ITR SET NOTE:
 THESE ITR SET DRAWINGS HAVE BEEN MARKED UP WITH KNOWN MARKUPS/REVISIONS IN PROCESS AS NOT TO BE RE-COMMENTED ON VIA THE ITR PROCESS & ADVISE ITR REVIEWER OF KNOWN FORTCOMING CHANGES. THESE MARKUPS HAVE BEEN DONE / IDENTIFIED WITH YELLOW BACKGROUND TEXT BOXES. PLEASE USE ALTERNATE COLOR FOR ITR COMMENTS WHICH I WILL REVIEW / TAKE INTO CONSIDERATION BEFORE CADD/DESIGN IS TO EXECUTE.

| DEPARTMENT OF THE NAVY NAVAL FACILITIES ENGINEERING COMMAND ~ MID-ATLANTIC JACKSONVILLE, NC MCB CAMP LEJEUNE JACKSONVILLE, NC P1338 II MEF SIMULATION/TRAINING CENTER REPLACEMENT MECHANICAL - SITE PLAN | | |

PRE-FINAL ITR SET 2021-05-28

PIPING - 1ST FLOOR PLAN - AREA C
SCALE: 1/8" = 1'-0"

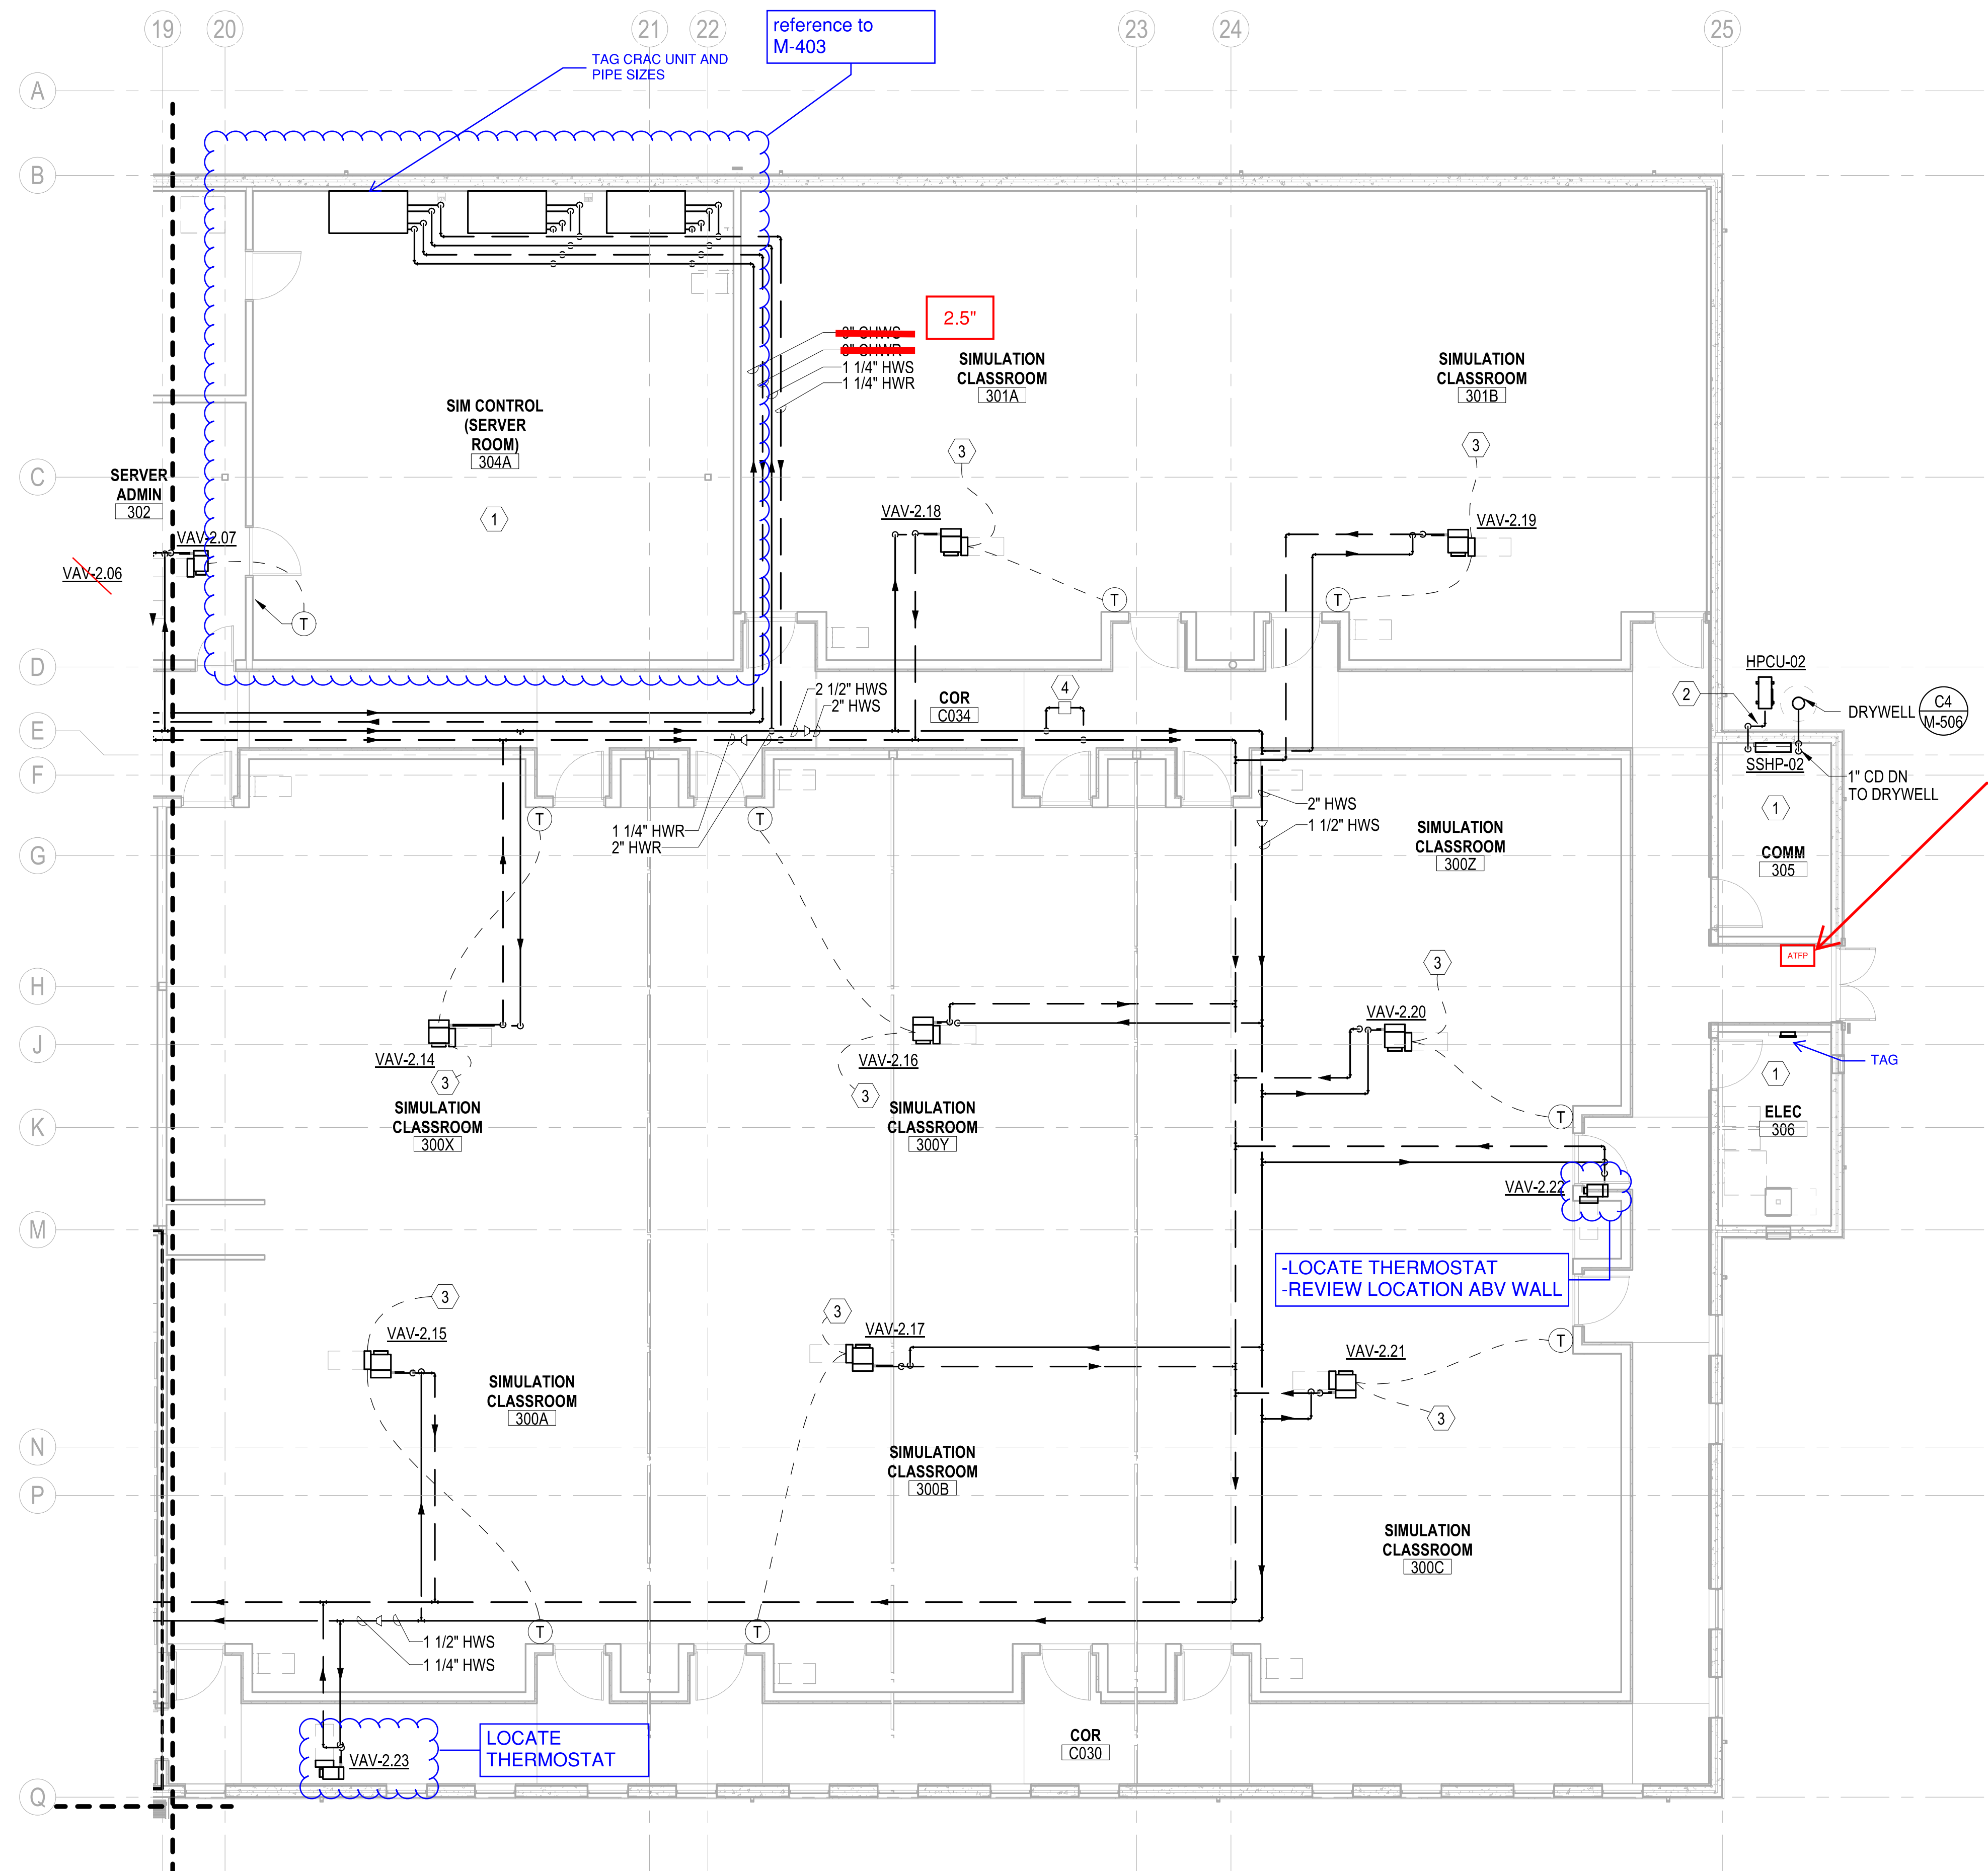
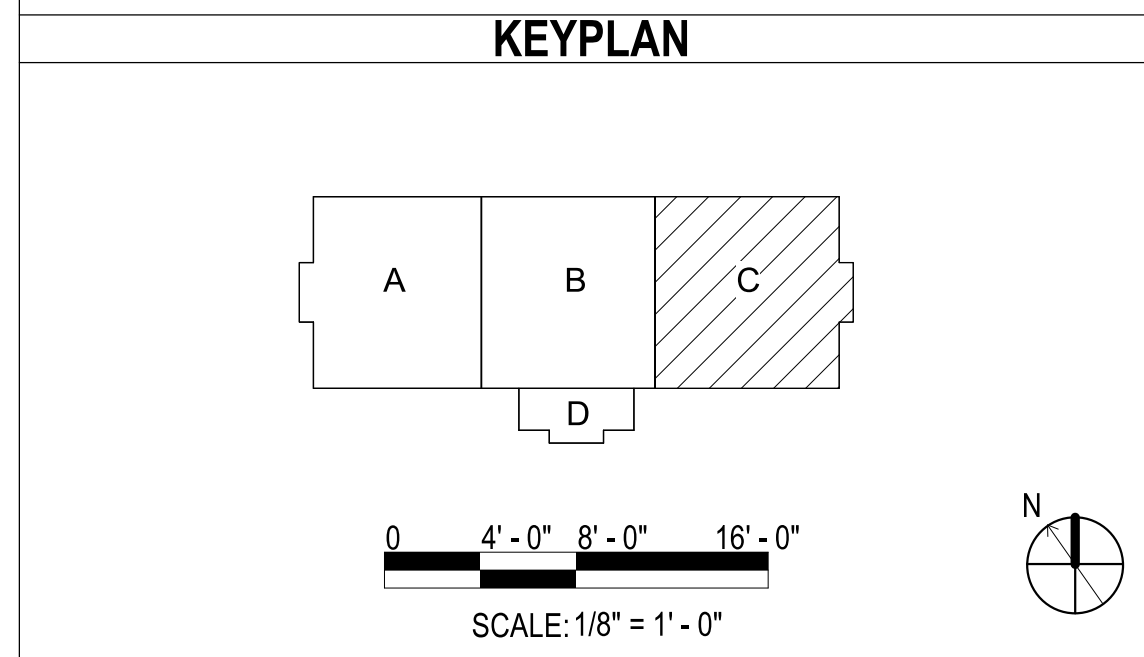
ADD ATFP SWITCH HERE

-LOCATE THERMOSTAT
-REVIEW LOCATION ABV WALL

LOCATE THERMOSTAT

MECHANICAL - ENLARGED PLANS

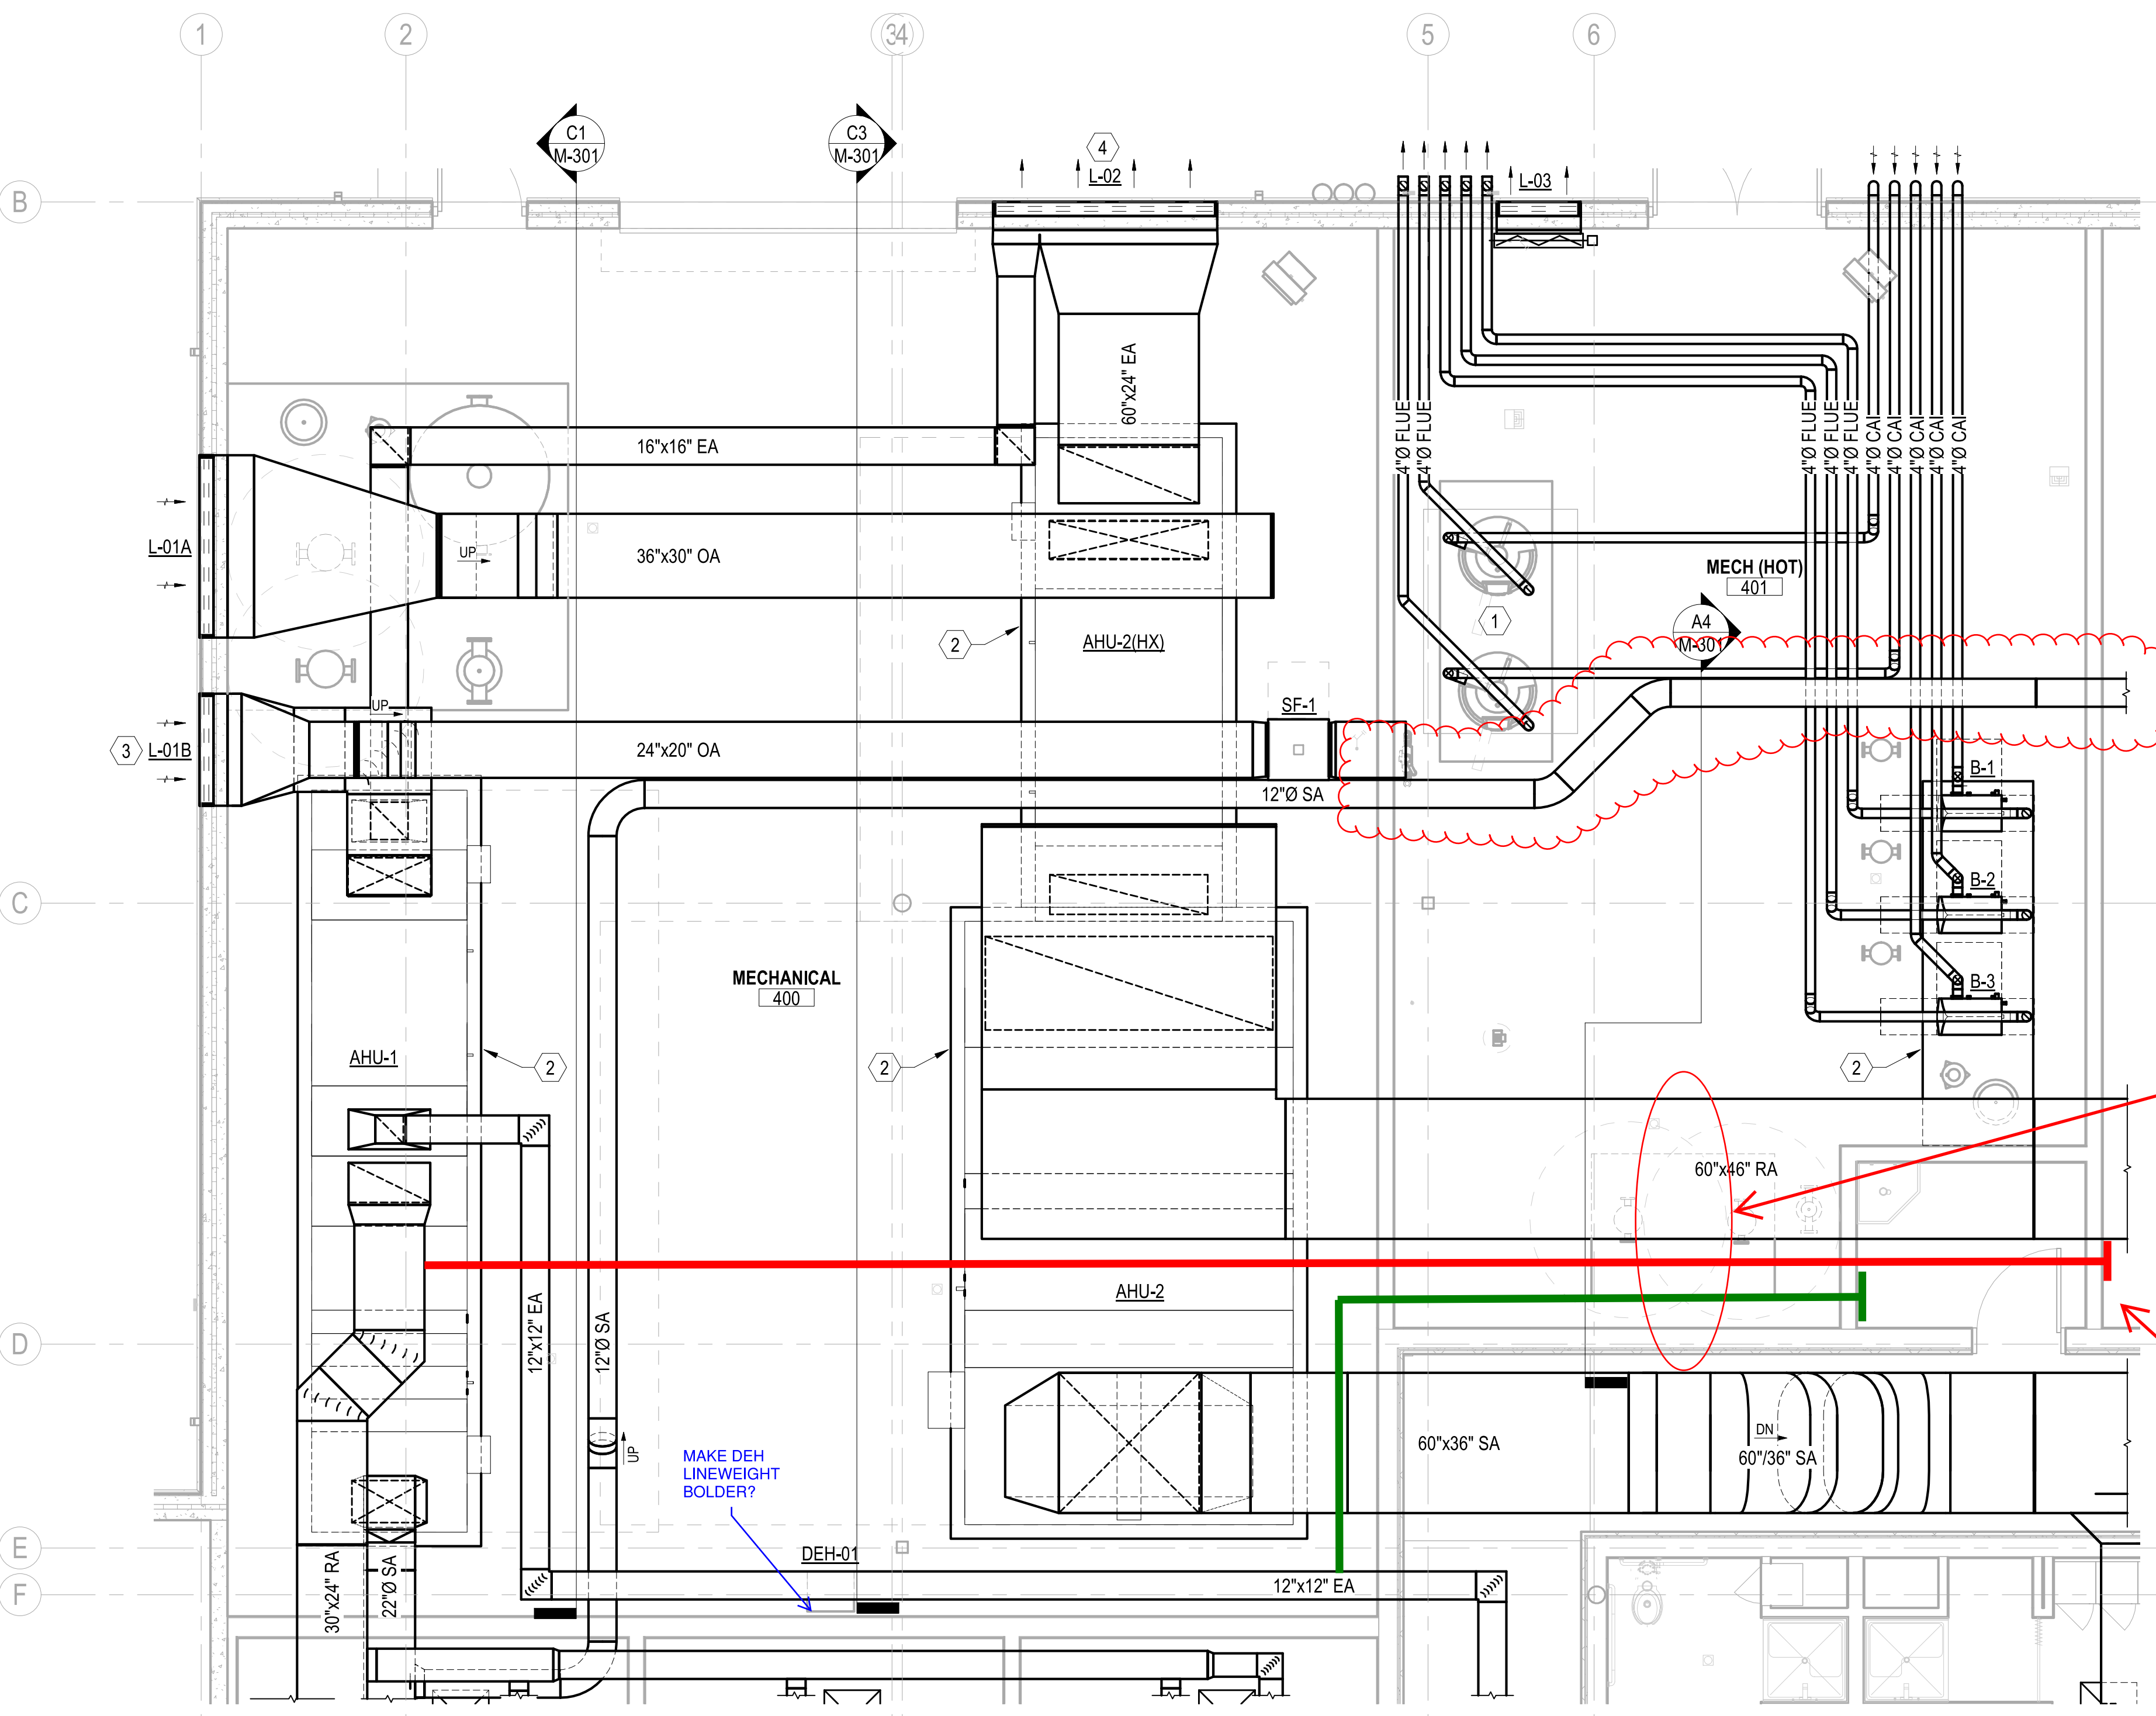
IF WE CAN FIND ANY WAY TO AVOID TAKING COLD SUPPLY DUCT THROUGH THIS "HOT" MECHANICAL ROOM THAT WOULD BE GOOD, THIS NEEDS TO BE LAST RESORT; IF UNAVOIDABLE, WILL NEED TO ANNOTATE AND BE CLEAR TO PROVIDE AN OUTDOOR RATED VAPOR BARRIER/PROTECTIVE COVERING OR SOMETHING TO ABSOLUTELY PREVENT ANY CHANCE OF CONDENSATION CONCERNS (THIS IS WHY THEY HAVE THE HOT & COLD ROOMS SEPARATE!)
